Access Compliance Report Public Rights-of-Way (Curb Ramps)

Main Street: N/A Cross Street: EDINGER_AVE Location: SW

ADA ID: RPRK220222162045 Ramp Type: Type 4 - Parallel Initial Pass/Fail: Fail Overall Compliance: No Severity Score: 2

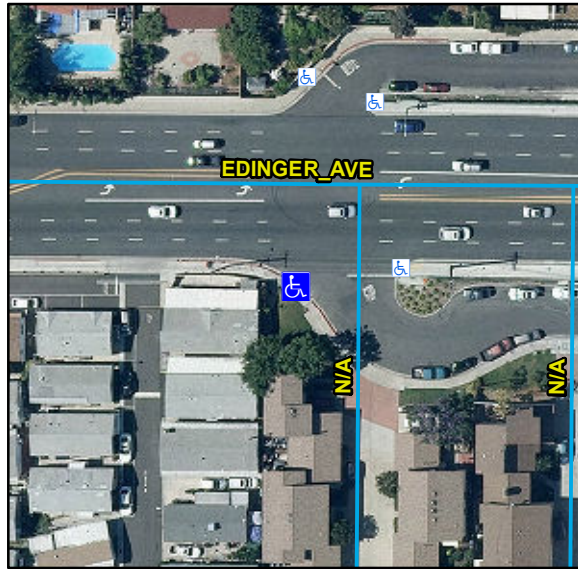
Compliance	Description	Data	Compliance	Description	Data
N/A	Ramp Length LT (in)	72	N/A	Ramp Length RT (in)	110
Yes	Ramp Width LT (in)	55	Yes	Ramp Width RT (in)	55
Yes	Ramp Run Slope LT (%)	7.6	Yes	Ramp Run Slope RT (%)	7.3
No	Ramp Cross Slope LT (%)	2.4	No	Ramp Cross Slope RT (%)	3.5
N/A	Landing Present	N/A	N/A	DWS Provided	N/A
N/A	Landing Length (in)	N/A	N/A	DWS Contrast	N/A
N/A	Landing Width (in)	N/A	N/A	DWS Length (in)	N/A
N/A	Landing Run Slope (%)	N/A	N/A	DWS Full Width	N/A
N/A	Landing Cross Slope (%)	N/A		DWS Offset Type	N/A
N/A	Landing Movement Obstructed?	N/A	N/A	DWS Offset Left (in)	N/A
	Landing Movement Type	N/A	N/A	DWS Offset Right (in)	N/A
N/A	Landing Shared	N/A			
N/A	Clear Space	Yes			
N/A	Clear Space To Crosswalk (in)	48			
N/A	Marked Crosswalk 1	No	N/A	Marked Crosswalk 2	No
	Crossing 1 Direction	E		Crossing 2 Direction	N
N/A	Marked Crosswalk 1 Width (in)	N/A		Marked Crosswalk 2 Width (in)	N/A

Remove & Replace Curb Ramp With Two New Directional Ramps or Equivalent.
